ADDENDUM NO. 2 TO PROJECT NO. 42535

PROVIDE ELECTRIC UPGRADE FOR FEEDERS, TRANSFORMERS, AND SWITCHGEAR SITEWIDE

GREENHAVEN CORRECTIONAL FACILITY
ROUTE 216
STORMVILLE, N.Y. 12582

February 21, 2013

DRAWING NUMBER: EL1.32B

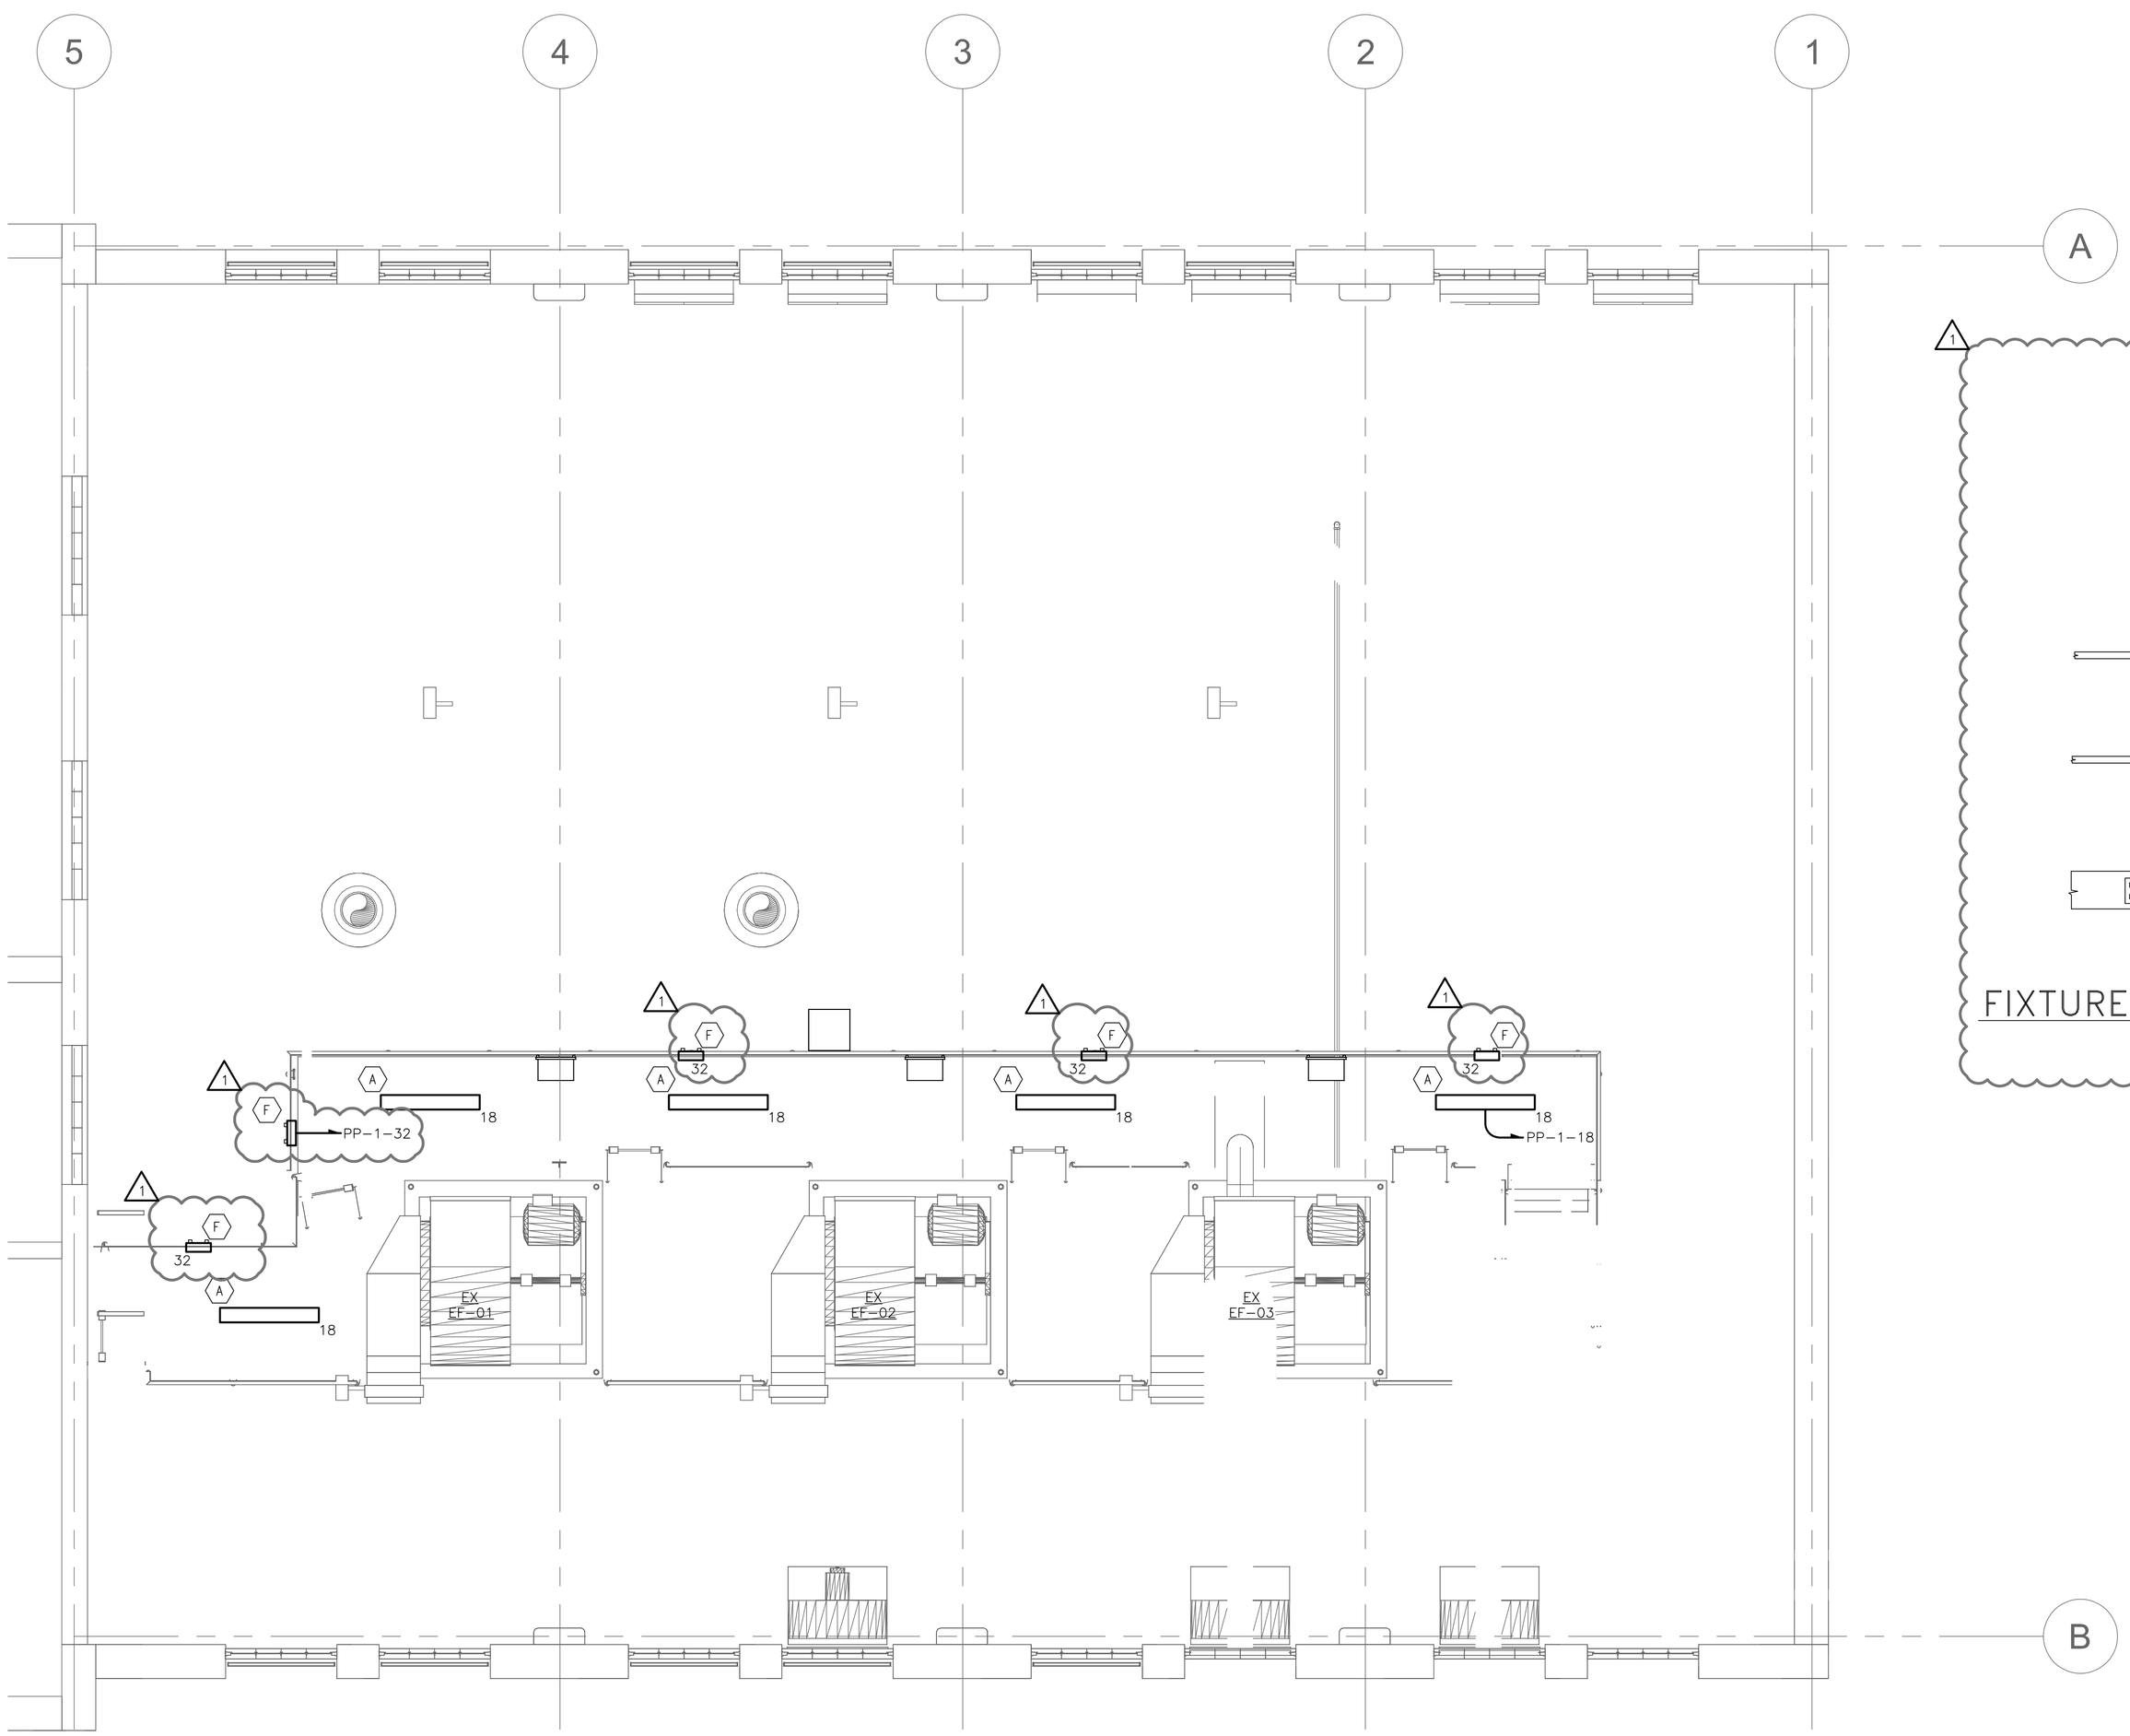
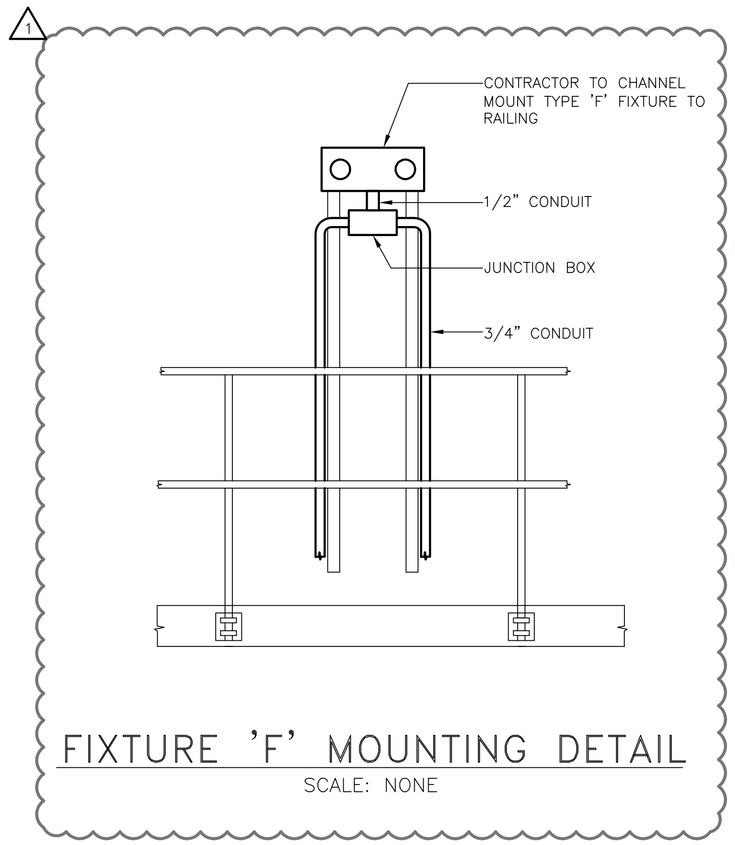
22. Drawing EL1.32B:
    a. Revise "ENGINE ROOM – UPPER LEVEL LIGHTING – ELEV. 437.0' – NEW WORK – PHASE 3". See accompanying drawing EL1.32B.

DRAWING NUMBER: EP1.22B

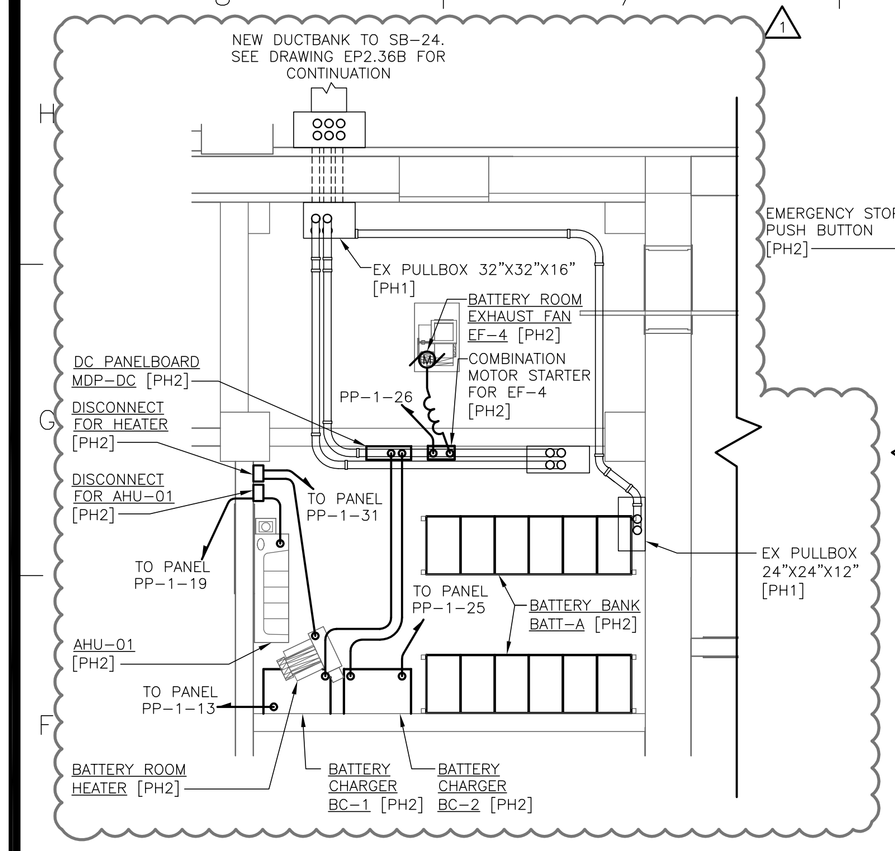
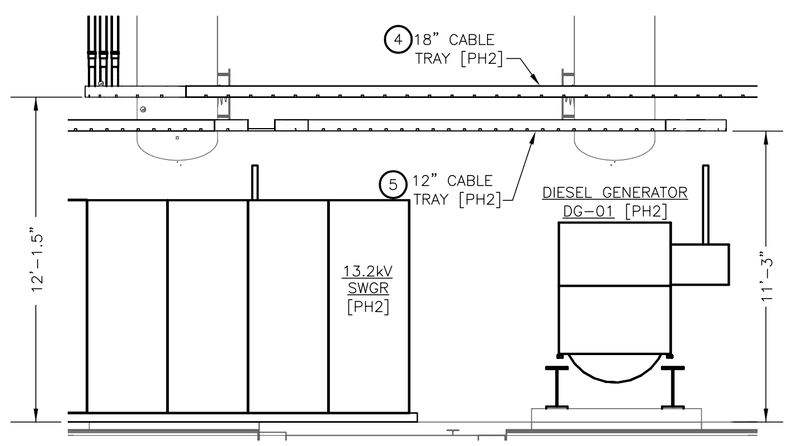
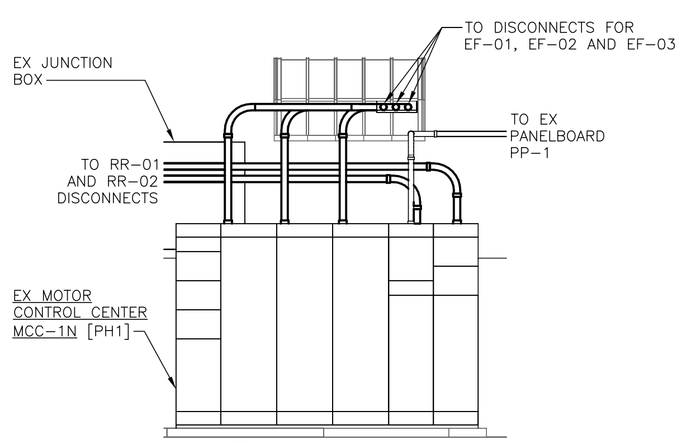
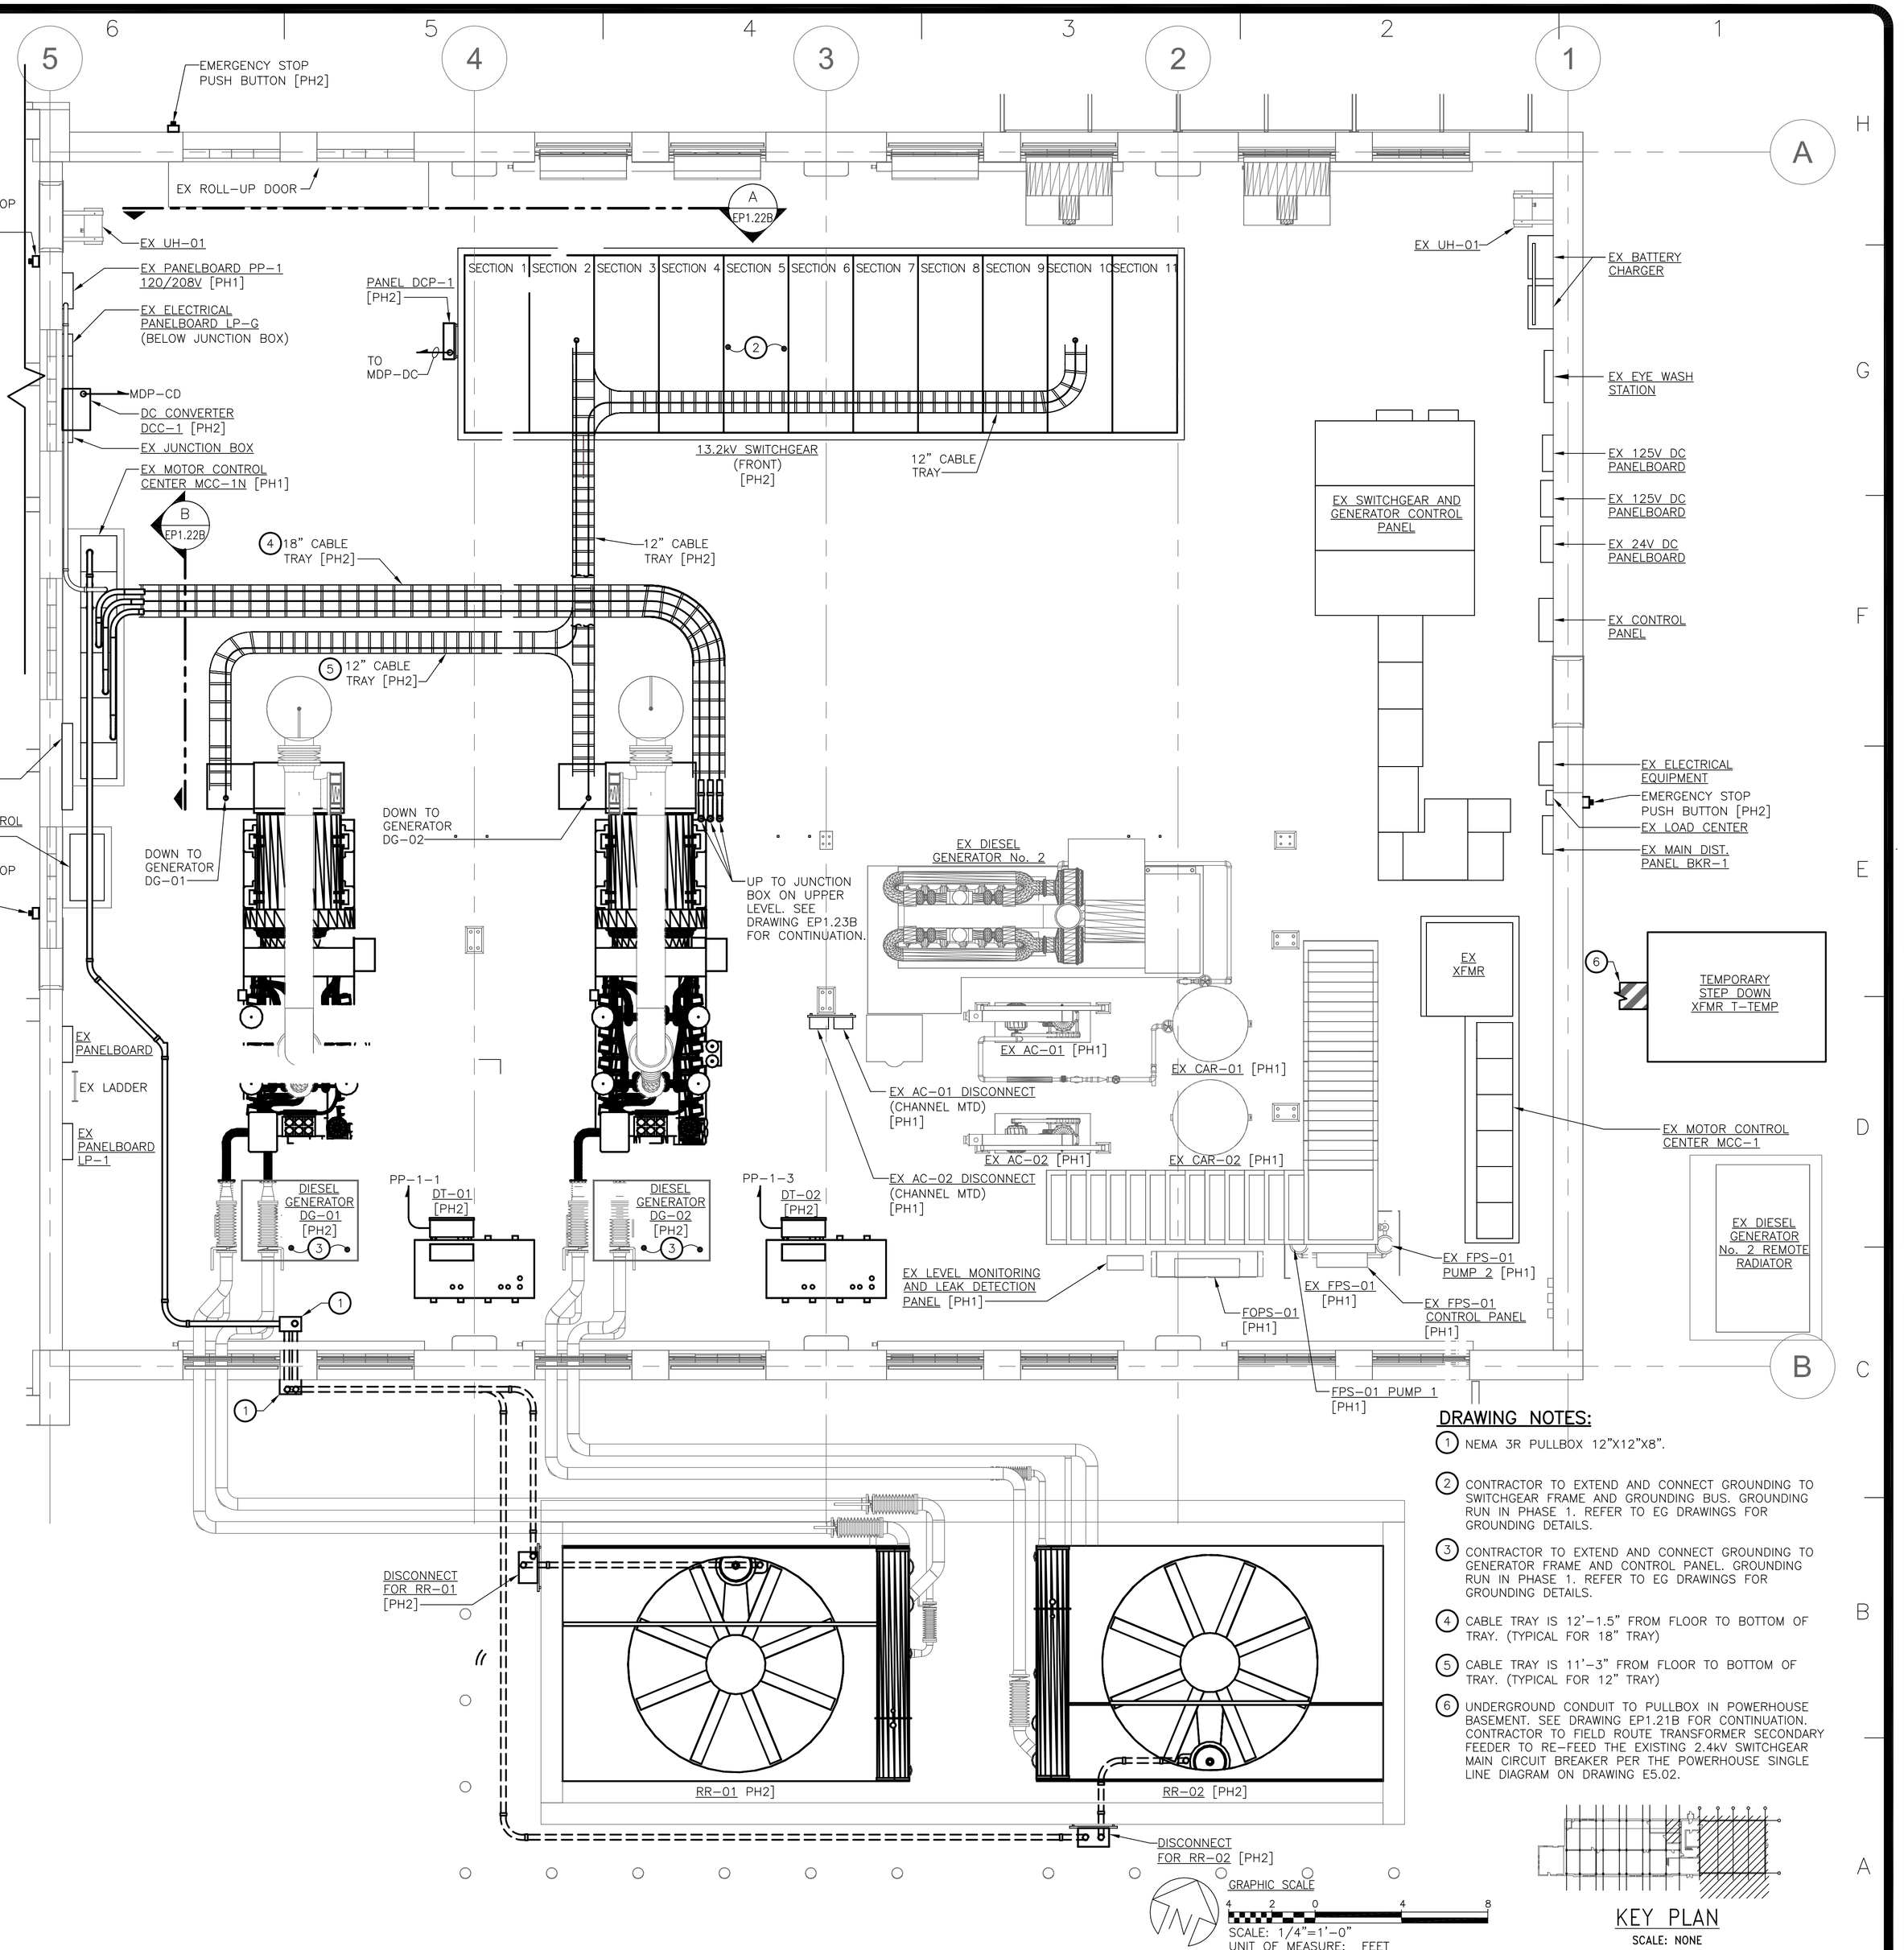
12. Drawing EP1.22B
    a. Revise the "ENGINE ROOM – LOWER LEVEL PLAN – ELEV. 422.5' – NEW WORK – PHASE 2". See accompanying drawing EP1.22B.

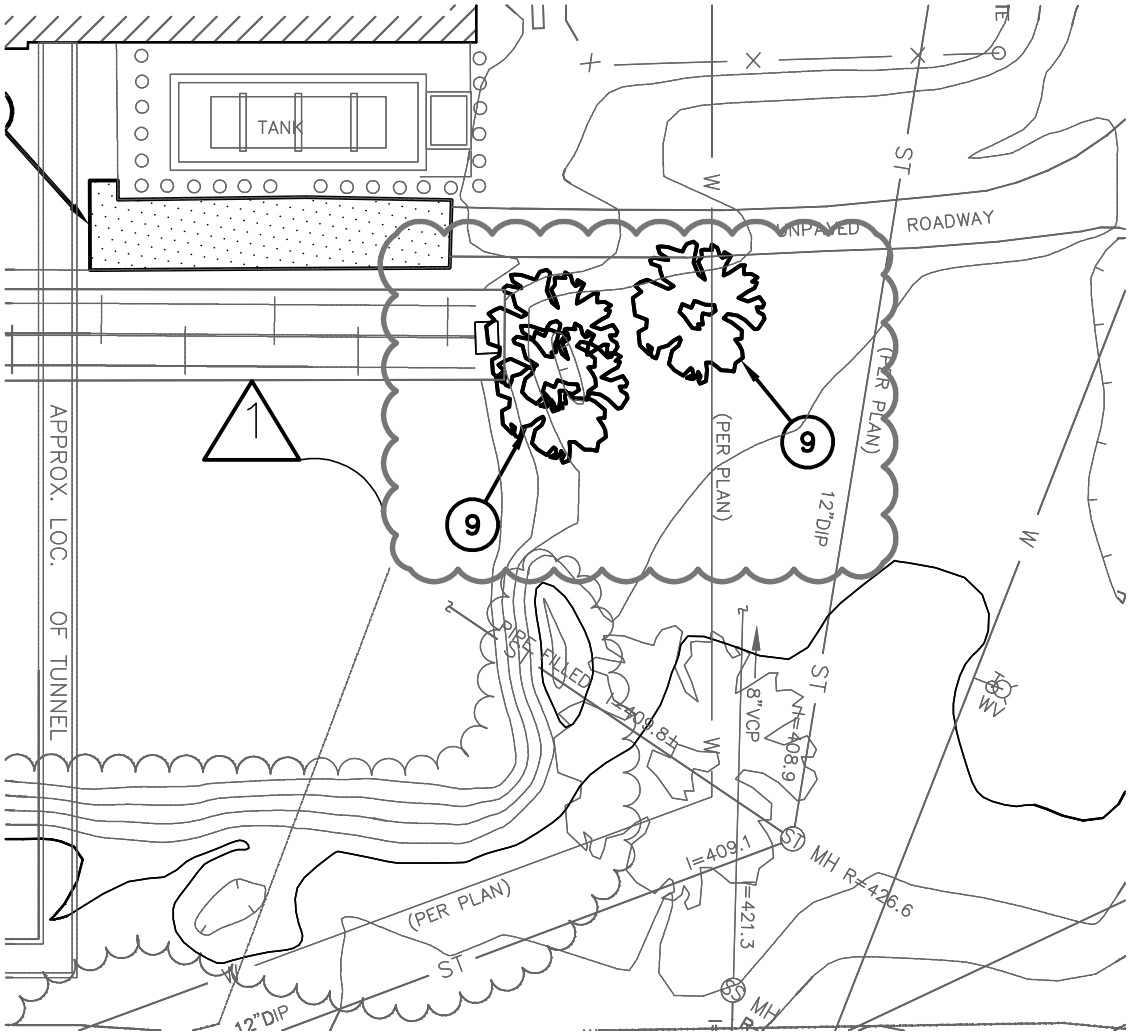
2. Drawing EC1.07:
   a. Revise the "DEMOLITION PLAN – AREA 7". See accompanying sketch SK-EC1.07-1.
